**NORTH SALT LAKE PLANNING COMMISSION  
NOTICE & AGENDA  
April 13, 2021  
6:30 p.m.**

**TO:** Planning Commission  
**FROM:** Mackenzie Bennett, Planner  
**DATE:** April 13, 2021  
**SUBJECT:** Site Plan for Wasatch Container Addition, 645 North 400 West

**TO:** Planning Commission  
**FROM:** Mackenzie Bennett, Planner  
**DATE:** April 13, 2021  
**SUBJECT:** Site Plan for Cyprus Credit Union, 450 East 1100 North

**TO:** Planning Commission  
**FROM:** Sherrie Pace, Community Development Director  
**DATE:** April 13, 2021  
**SUBJECT:** Love Carpet Cleaning 580 North Main Street

PROJECT NUMBER: 9802  
 PRINT DATE: 4/7/21  
 DRAWN BY: MIKE WINTERS  
 CHECKED BY:  
 PROJECT MANAGER: DAVID JENKINS, PE

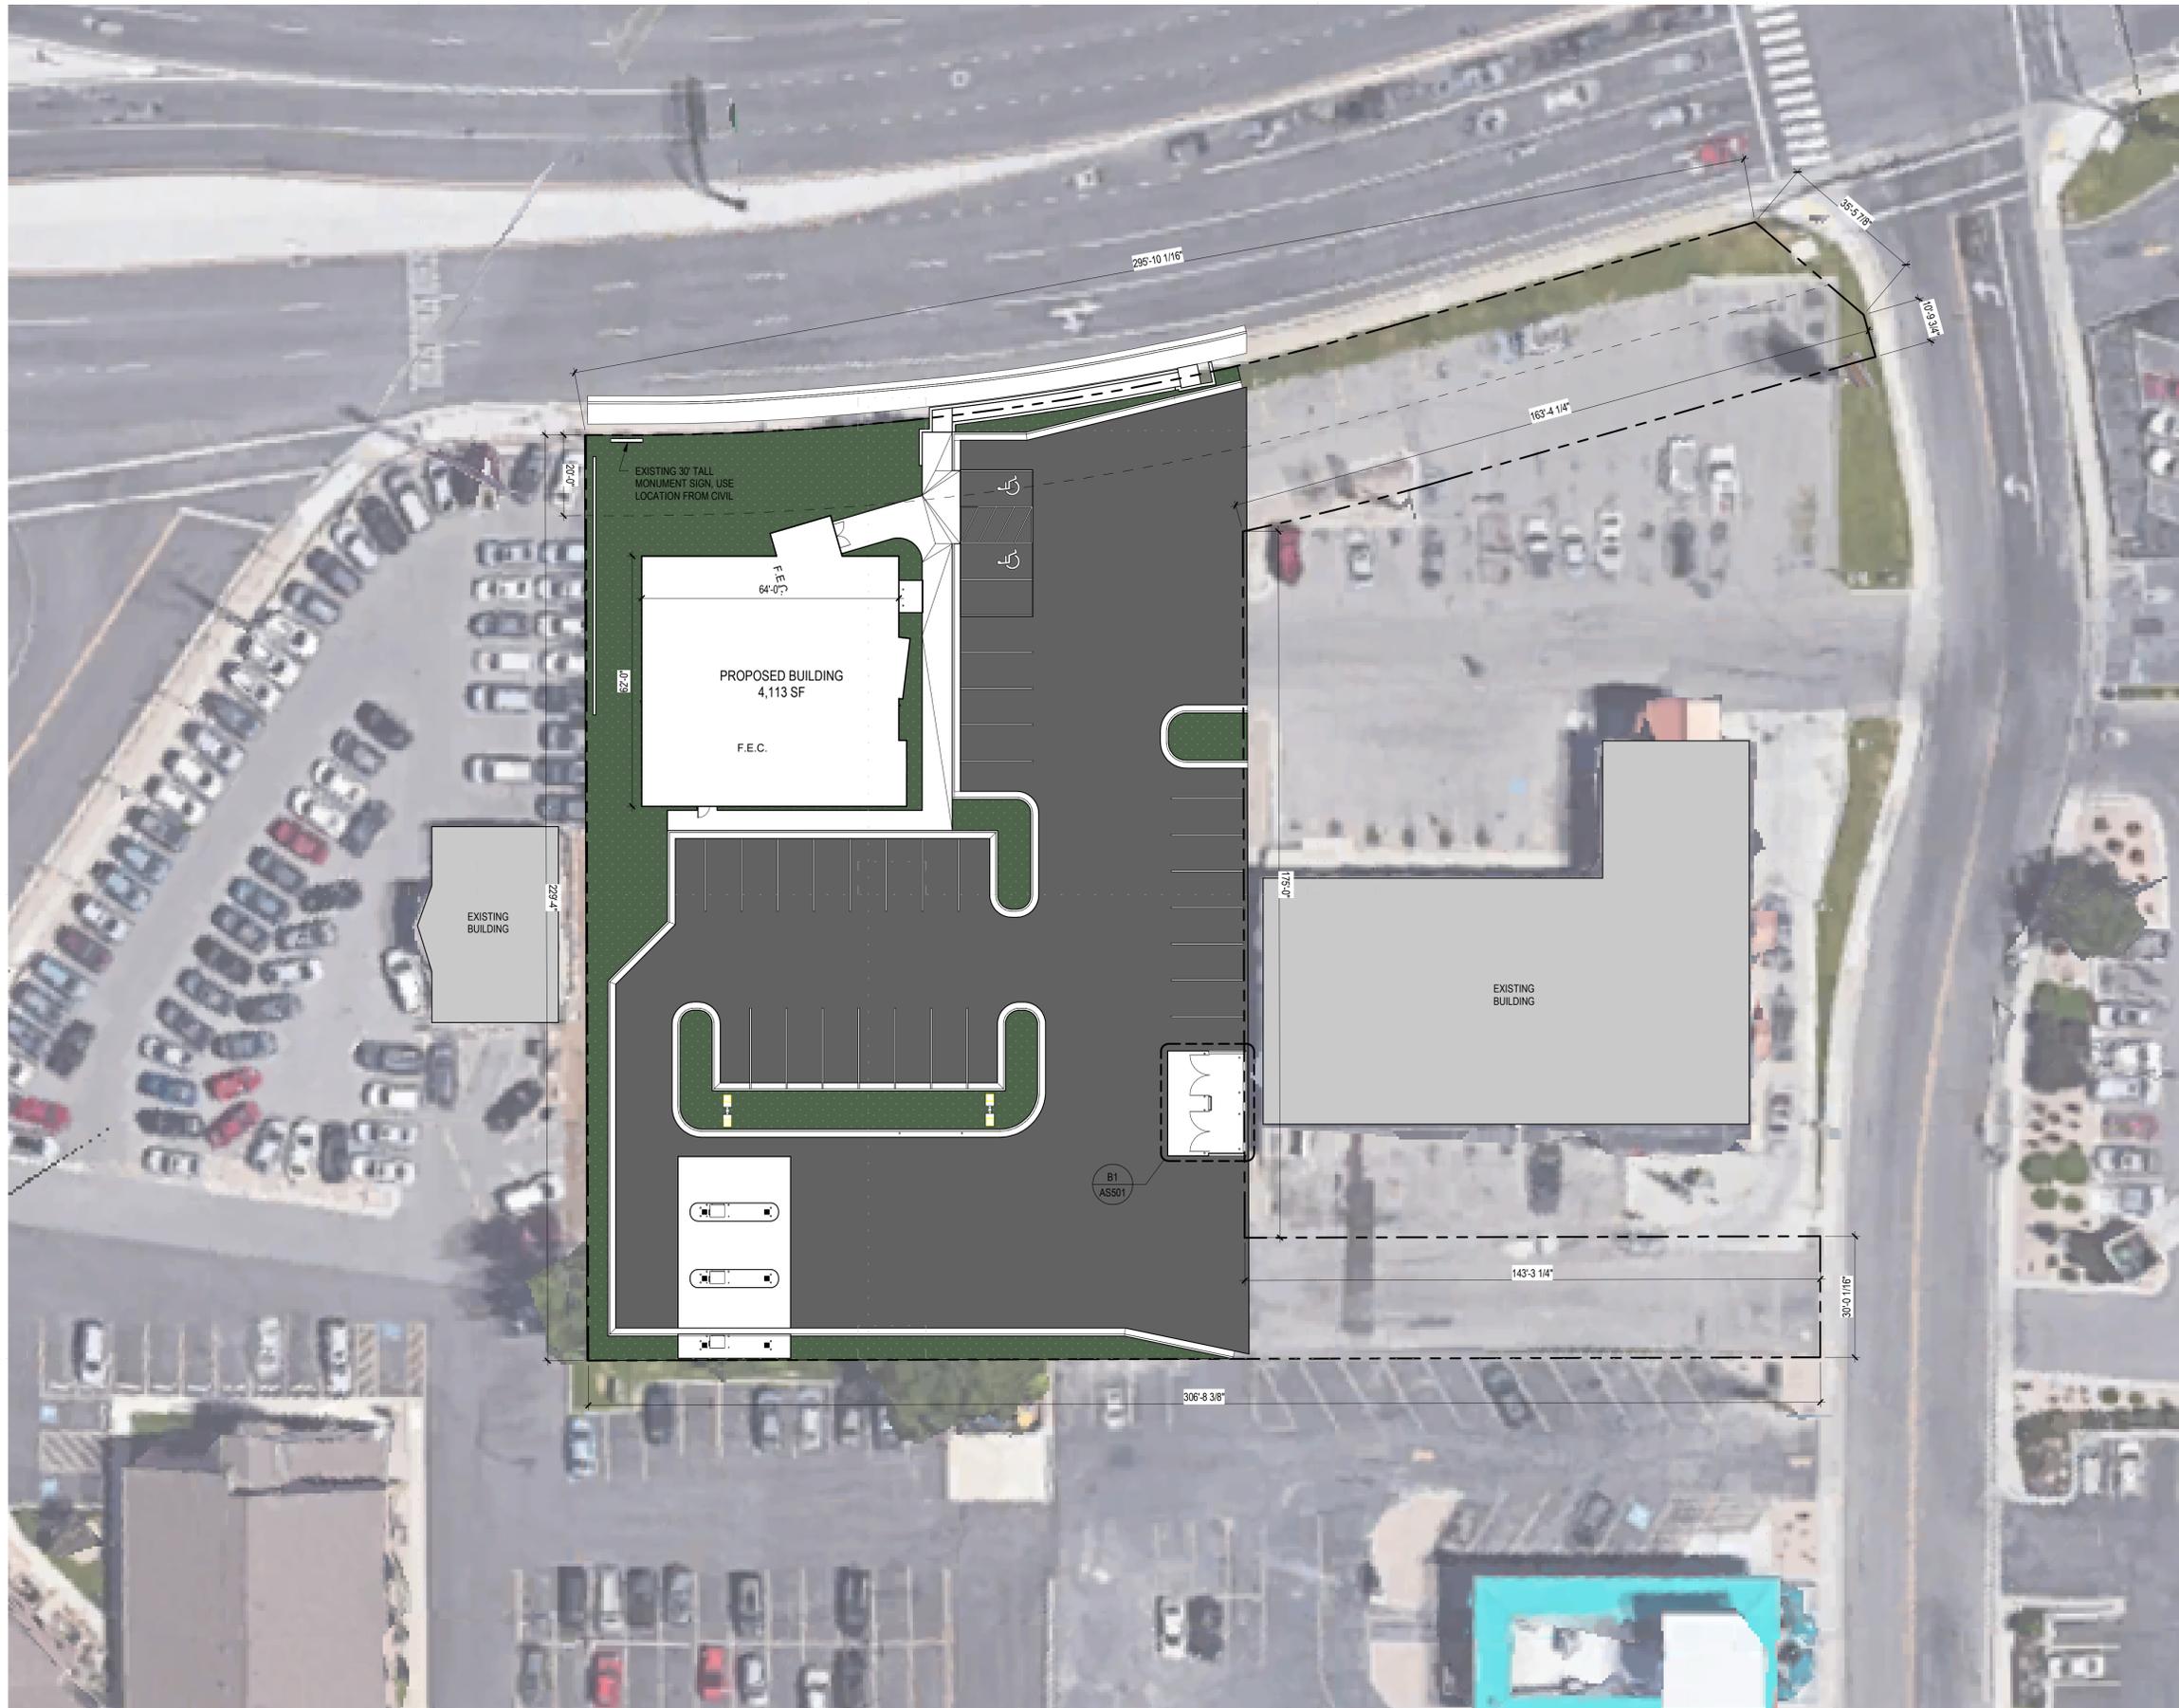
1. Obtain approval from UDOT to construct a sidewalk and retaining wall within their right-of-way;
2. Provide a letter, prior to final occupancy, from a licensed surveyor certifying that the storm drain system has been constructed to the design elevations and that the overall system will operate as designed;
3. Engineering redlines, if any.

# Proposed Amended Elevation

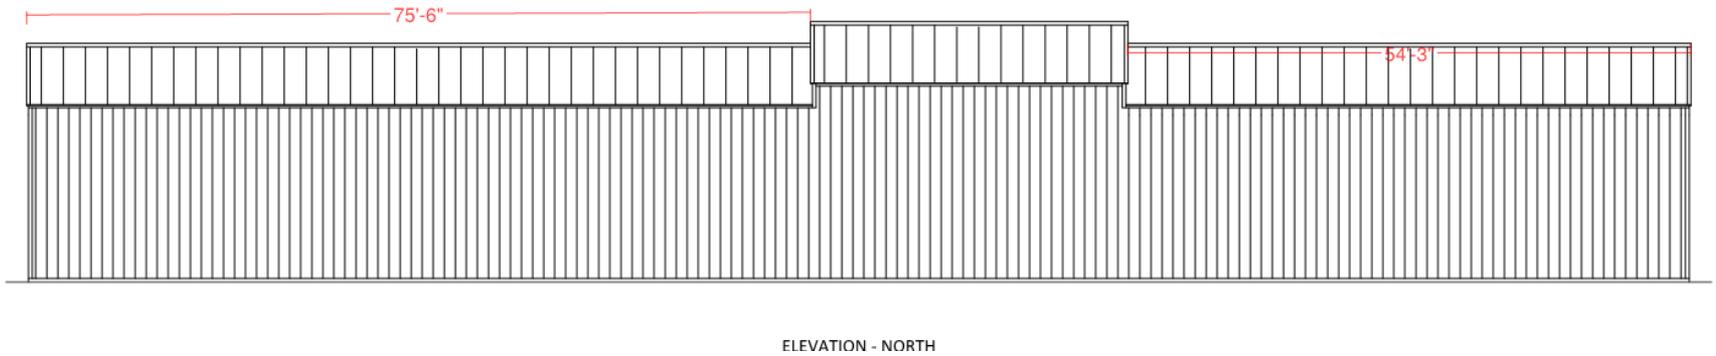
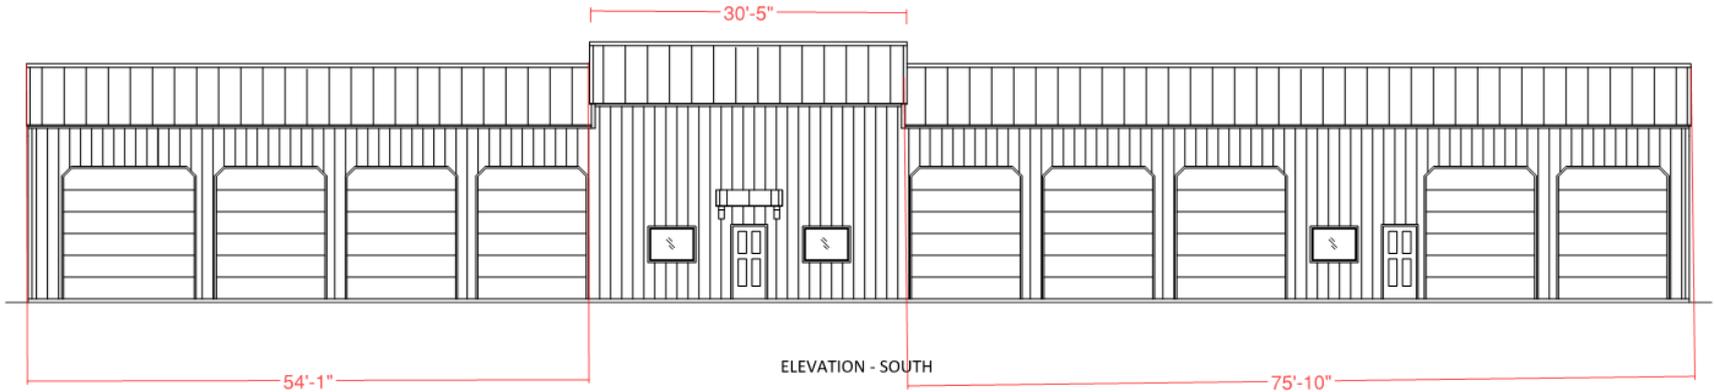
The previously approved elevation approved had the center section of the building raised to a height of eight (8) feet above the rest of the roof. The previous plan also contained cupolas, which are proposed

to be removed. The previous plan had the cupolas to break up a roof line greater than 60 feet. The proposed amendment has an uninterrupted roof of longer than 60 feet at approximately 76 feet in length. There is also no awning over the far east door that needs to be added. The requested change relates to the expense of the steel structure to vault the middle section of the building

add  
awnings over doors

1. All previous conditions of approval are in affect;
2. The center section of the building include a roof element such as a clerestory that extends to a length to ensure that that no portion of any roof line is greater than 60 feet without height variation;
3. An awning is added to the east door, similar to the center door.

Alternative options available for the design would be to add a clerestory to the structure, that may or may not contain windows. The clerestory would need to extend over the middle section so that no other section of roof line was longer than 60 feet. An example is attached as a staff recommended alternative, other designs using the cupolas could be used as well.
